Attachment to Appendix Z

Comment Letters #2 - #19

Comments on Preliminary Draft Staff Report
Proposed Amendments to Regulation XX
Regional Clean Air Incentives Market (RECLAIM)
NO_x RECLAIM – SCRs for FCCUs
Document No. 14-045-7

Figure 1

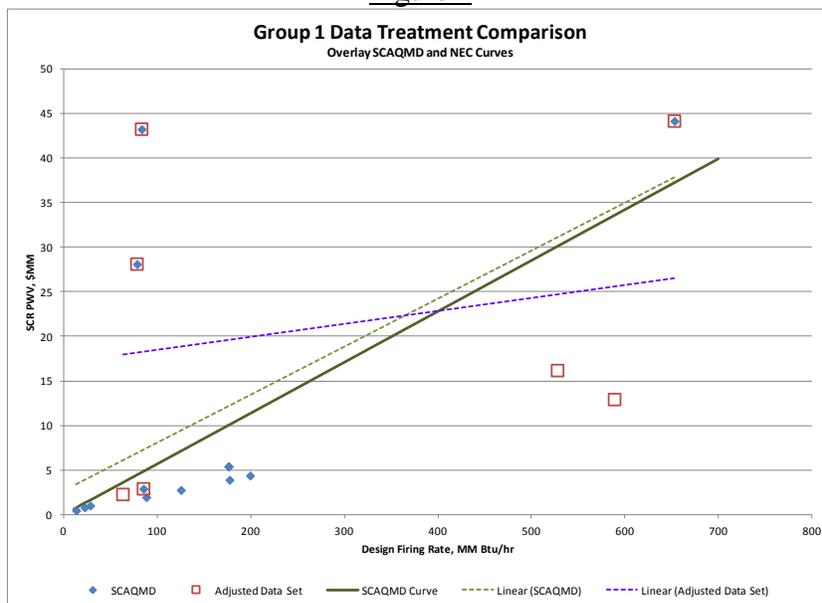
The following figures provide an illustration of the effect of staff’s cost allocation assumption on the estimated PWVs of small heaters. Figure 1 presents two sets of survey cost data denoted as Group 1 data in the draft report. The data set named SCAQMD includes the parsed PWV data for three of the seven best performing SCRs in the district resulting in a total of fourteen data points. The data set named “Adjusted Data Set” combines the duties of the seven heaters which share SCRs into three data points yielding a total of seven data points. The revised data points represent SCR systems designed for a heater with a size equal to the combined firing rate of all the heaters sharing the SCR. Linear regressions of the parsed and non-parsed data are shown as dashed lines in the figure. The solid line is staff’s PWV relationship. While the data is widely scattered and does not curve fit very well ($R^2 = 0.3$ for curve fit of parsed data and 0.05 for non-parsed data) the slopes of the two curves

are very different and indicate that staff's correlation likely under predicts PWVs for heaters smaller than 400 MM Btu/hr; quite a different conclusion than that drawn in the draft report.

Figure 2

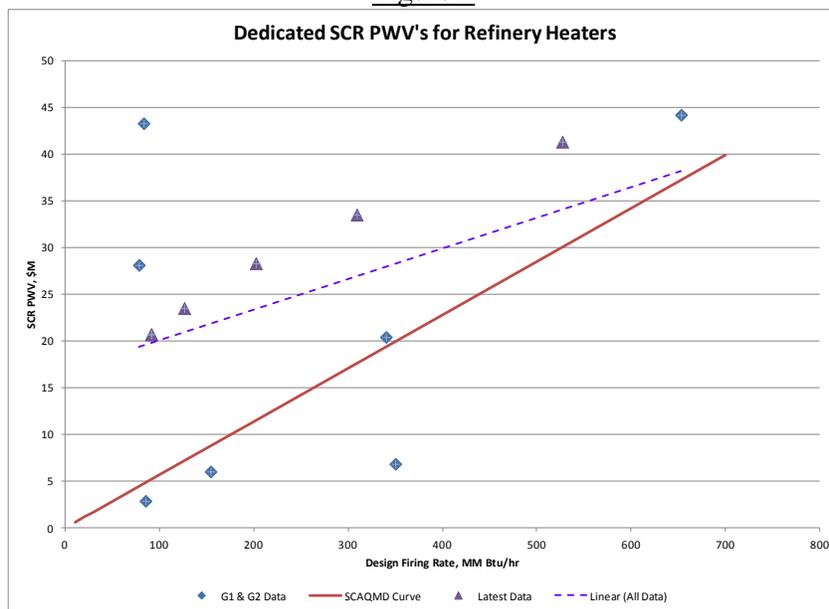
Norton Engineering understands that the number of survey project and operating cost data points on high performing SCR units is both limited and scattered and that additional information is needed and has been used by staff to generate more representative PWVs for refinery heaters. Figure 2 provides a comparison of staff's PWV correlation with available Group 1, Group 2 and additional SCR project cost estimate data provided to AQMD by a district refinery during NEC's review. All data are for dedicated SCR installations.

The purple dashed line in the figure represents a linear regression line for all the chart data. As with Figure 1, the large scatter in the data makes the correlation, any correlation, almost meaningless. The conclusion we can reliably draw from this chart is that staff’s PWV correlation under predicted PWVs (based on actual and estimated TICs) in eight out of twelve instances, over predicted PWVs in one out of twelve instances and was accurate in three out of twelve instances. If staff’s correlation was conservative we would expect that it would over predict PWVs more often than it under predicted PWVs. That is clearly not the case.

Figure 3 is a repeat of Figure 2 including NEC’s proposed PWV correlation and the cost bands recommended for use in estimating complex and simple, single heater – single SCR PWVs.

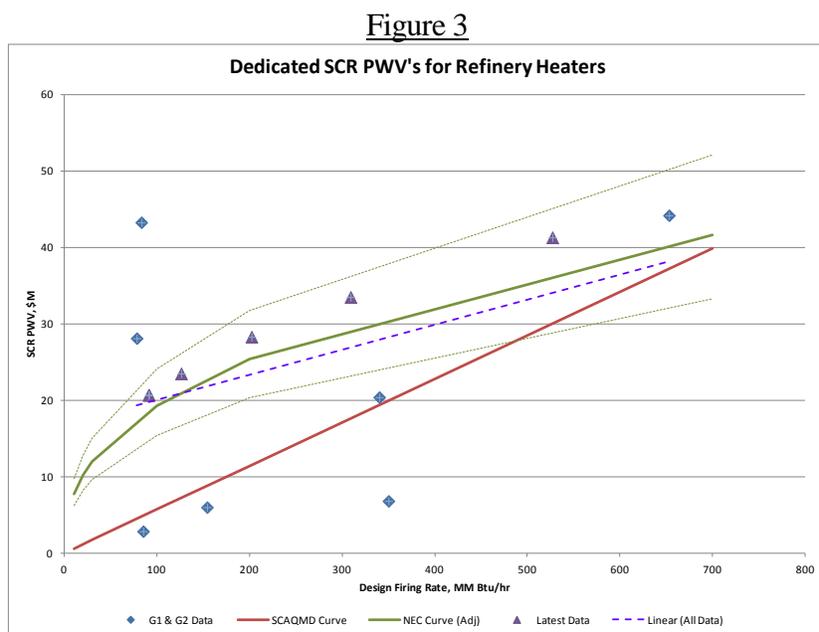
NEC’s proposed correlation provides PWV estimates for dedicated SCR projects which are more representative than staff’s proposed correlation, matches up pretty well with the linear correlation of all data and, is not overly conservative. Six data points are higher cost than predicted by NEC’s correlation, four are lower cost and two are predicted pretty accurately. When the complexity bands are used, the correlation under predicts in two of 12 cases, over predicts in four of twelve cases and is “accurate” in six of twelve cases.

For the specific case of smaller heaters (<100 MMBtu/hr heat release) NEC’s correlation shows a very steep slope indicating that costs for small heater SCR installations rapidly increase with increasing heater size. This size sensitivity is expected as fixed project costs and non-size dependent project costs are normally a higher percentage of small projects than they are of larger projects. Staff’s proposed correlation does not show this trend and therefore can be expected to significantly under predict PWVs for smaller heaters.
